Item 3.**Development Application: 92 Glebe Point Road, Glebe - D/2019/42**

File No.: D/2019/42

Figure 8: Proposed southern elevation presenting to Mitchell Street with fabric awnings (shaded pink), signage and outdoor dining.

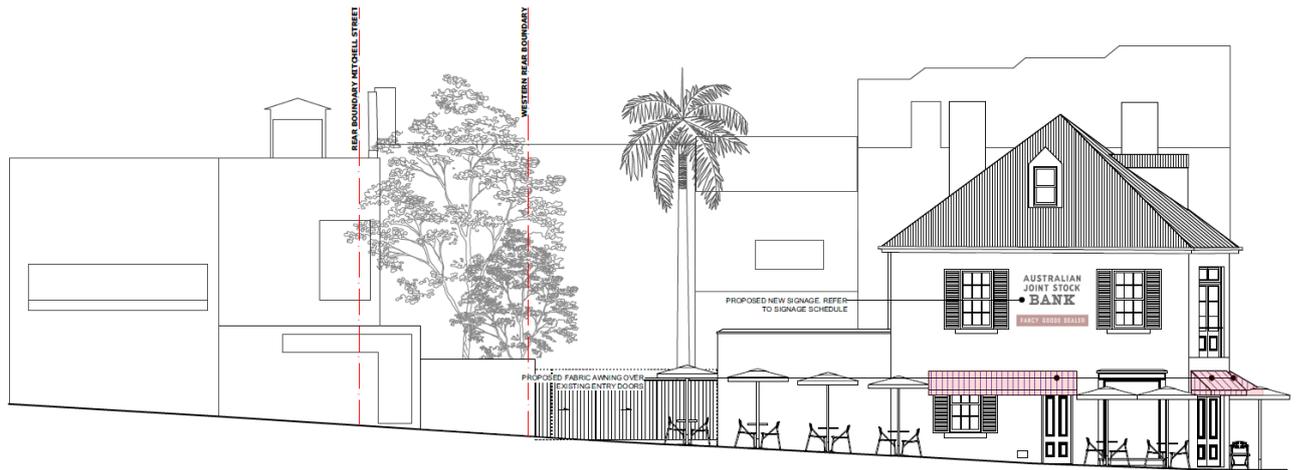
47. The proposed signage has a height of 1.55m, the distance between the first floor window sill and proposed awning is only 1.2m, therefore the proposed signage would need to be reduced in scale. Whilst the Heritage Specialist's recommendation would normally be supported regarding the location of the signage the introduction of the awning above the doorway requires flexibility to the signage location. The proposed location of the signage centred between the two first floor windows is supported as the most appropriate location given the location of the proposed awning.

43. The following conditions are recommended for the proposed awnings and replacement window to retain the integrity of the item as discussed above:
- (a) The extent of the awning on the Mitchell Street elevation is to be reduced to the width of the door opening only.

Figure 9: Proposed eastern elevation presenting to Glebe Point Road. Works (shaded pink) include the replacement of the front ground floor window, installation of fabric awnings and outdoor dining

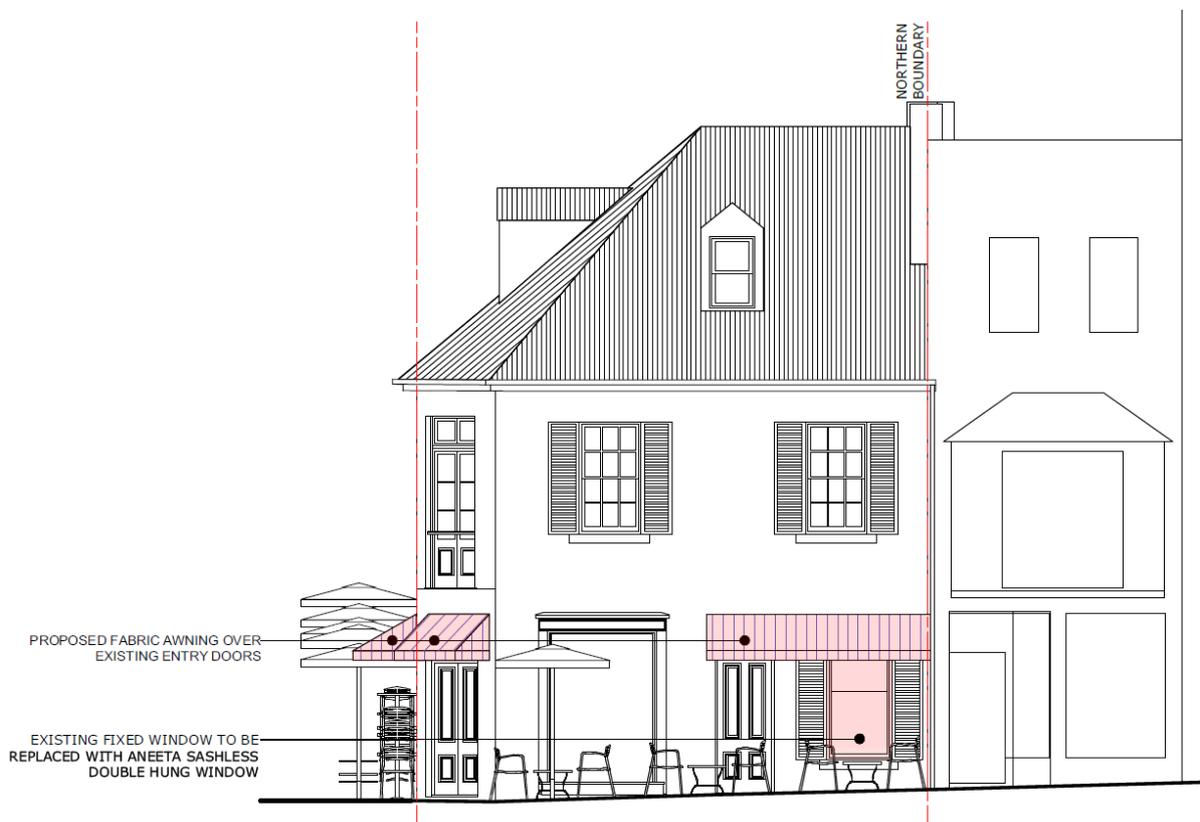
41. The works including the replacement of the fixed front window with a sashless double hung window and the installation of fabric awnings over the entries have been reviewed by the City's Heritage Specialist and these works are considered to be acceptable and will have a minor impact on the heritage significance of the building.

- (b) The extent of the awning on the Glebe Point Road elevation is to be reduced to the width of the door opening only.
 - (c) A typical section shall be submitted prior to the issuing of any Construction Certificate showing the awning to be cantilevered above the doorway and include details of the covering, framing, as well as fixing locations and details.

- (f) No signage is permitted on the awnings or the umbrellas proposed for the outdoor seating area.
 - (g) The framing of the “Aneeta” sashless double hung sash window shall be timber and not aluminium.

Figure 11: Recommended Reduction in outdoor dining area to accommodate a maximum of 20 patrons.

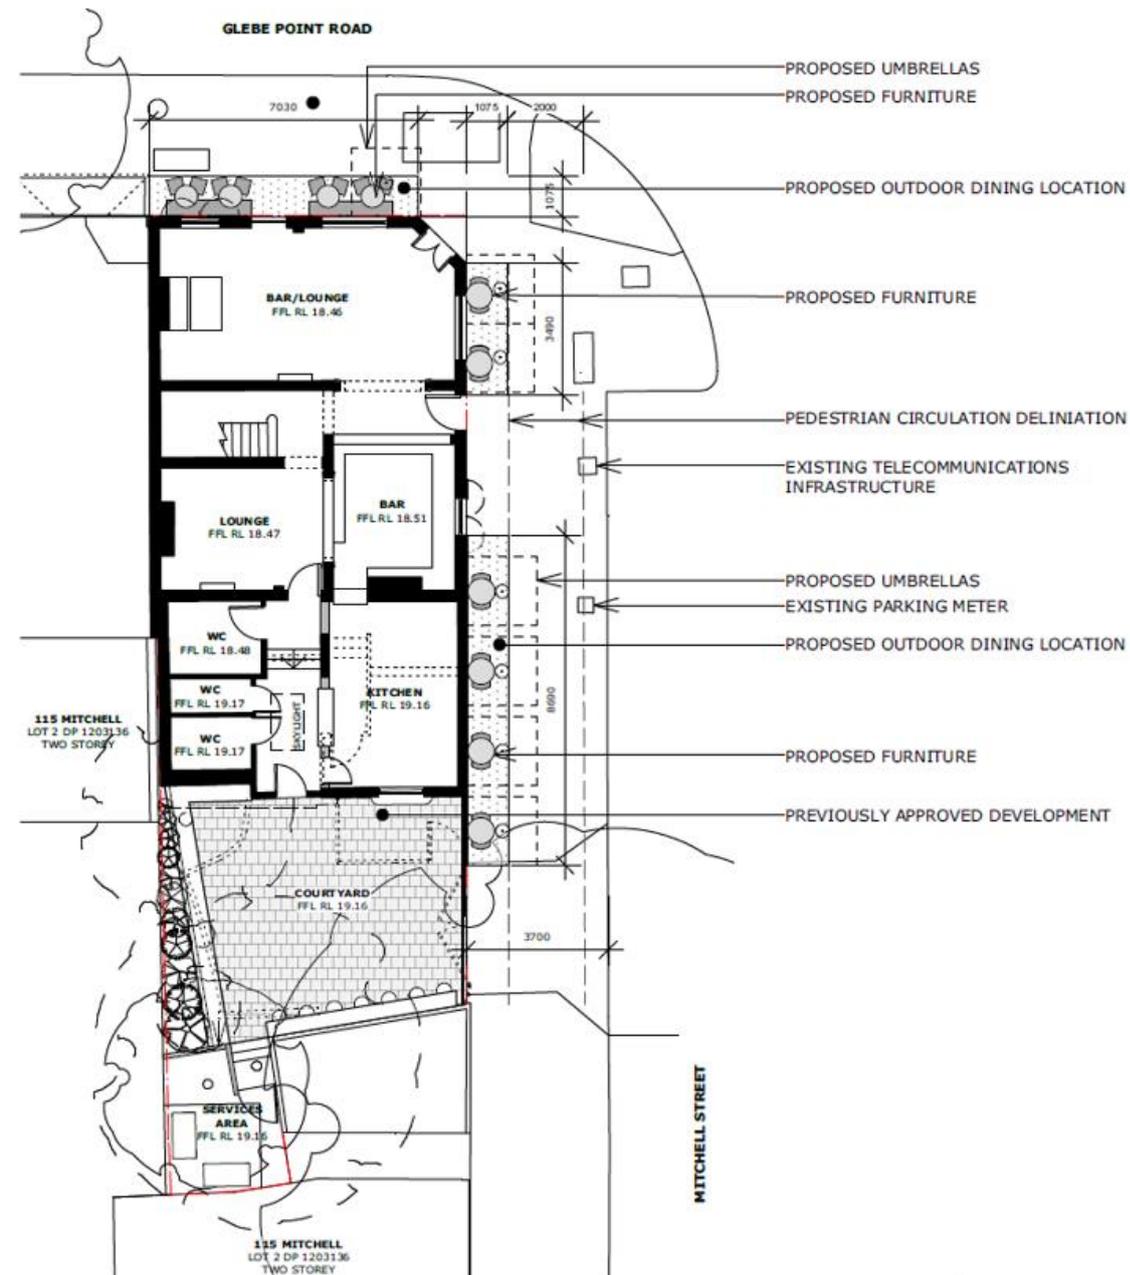
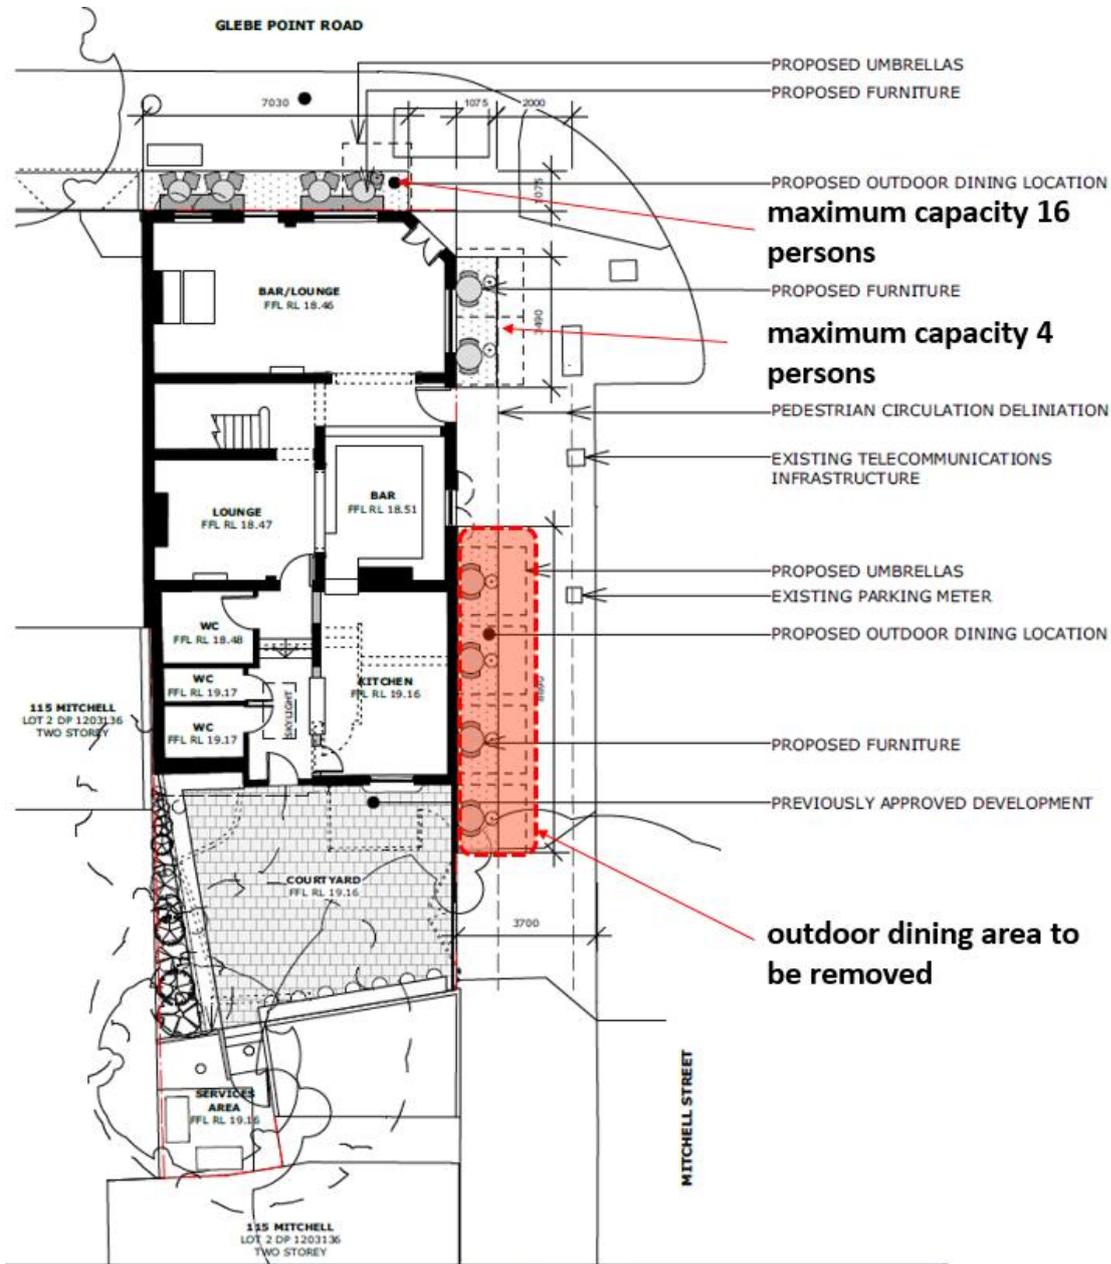
- (a) seating and furniture in the rear courtyard to reflect a maximum capacity of 20 patrons;
- (b) the outdoor dining area along Mitchell Street to be significantly reduced by deleting the 9.3 sqm area as shown in the diagram below to provide for a maximum of 20 patrons within the footway overall (16 patrons on Glebe Point Road and 4 patrons on Mitchell Street). The Acoustic Report also recommended a maximum capacity for the footway of 20 patrons. The current application and associated footway application is seeking a maximum footway capacity of 30 patrons;

58. The proposed capacity is 30 patrons, 14 patrons along Mitchell Street and 16 patrons on Glebe Point Road. The proposed hours of operation are Monday to Sunday 8.00am to 9.00pm.
59. The aims of the Policy are to promote accessibility on the footway by maintaining a consistent and predictable clear path of travel for all users and manage neighbourhood amenity through minimising additional noise, visual, and other impacts.

60. As stated above the maximum capacity of the outdoor dining area is recommended to be 20 patrons. The recommended removal of a portion of outdoor dining on Mitchell Street (refer Figure 11 below) will reduce the amenity impacts to surrounding residential properties by significantly reducing the number of patrons within this residential street from 14 patrons to four patrons and locating those remaining patrons closer to the intersection with Glebe Point Road.
